Access Compliance Report

Public Rights-of-Way

(Curb Ramps)

Intersection ID: 46599	Main Street: SHOPTON_RD	Cross Street: COURTNEY_OAKS_RD	Location: SE
ADA ID: 0237C5713515	Ramp Type: PerpDiag	Initial Pass/Fail: Fail	Overall Compliance: No
Severity Score: 33.75			
Codes/Mitigation Info/Possible Solution		Field Measurements/Component Compliance

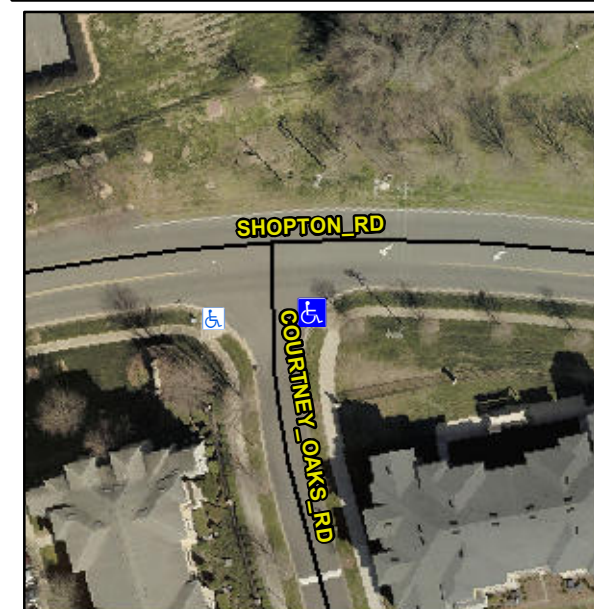
R304.5.1, R304.5.3

Compliance	Description	Data	Compliance	Description	Data
N/A	Ramp Length (in)	95.5	Yes	Ramp Slope (%)	6.6
No	Ramp Width (in)	41.0	No	Ramp XSlope (%)	7.3
N/A	Flare Type LT	N/A	N/A	Flare Type RT	N/A
N/A	Flare Slope LT (%)	N/A	N/A	Flare Slope RT (%)	N/A
N/A	Flare Traversable LT?	N/A	N/A	Flare Traversable RT?	N/A
N/A	Landing Length (in)	N/A	N/A	DWS Provided?	N/A
N/A	Landing Width (in)	N/A	N/A	DWS Contrast?	N/A
N/A	Landing Slope (%)	N/A	N/A	DWS Length (in)	N/A
N/A	Landing X Slope (%)	N/A	N/A	DWS Full Width?	N/A
N/A	Landing Curb? (Y/N)	N/A	N/A	DWS Offset (in)	N/A
N/A	Shared Landing?	N/A			
N/A	Gutter Ponding?	N/A	N/A	Gutter Slope (%)	N/A
N/A	Gutter Lip Ht (in)	N/A	N/A	Gutter X Slope (%)	N/A
N/A	Painted X Walk1?	No	N/A	Painted X Walk2?	No
	X Walk 1 Direction	To N		X Walk 2 Direction	To W
N/A	X Walk 1 Width (in)	N/A	N/A	X Walk 2 Width (in)	N/A
	X Walk 1 Slope (%)	3.7		X Walk 2 Slope (%)	2.1
	X Walk 1 X Slope (%)	5.2		X Walk 2 X Slope (%)	4.0

Remove & Replace Curb Ramp With Two New Directional Ramps or Equivalent.
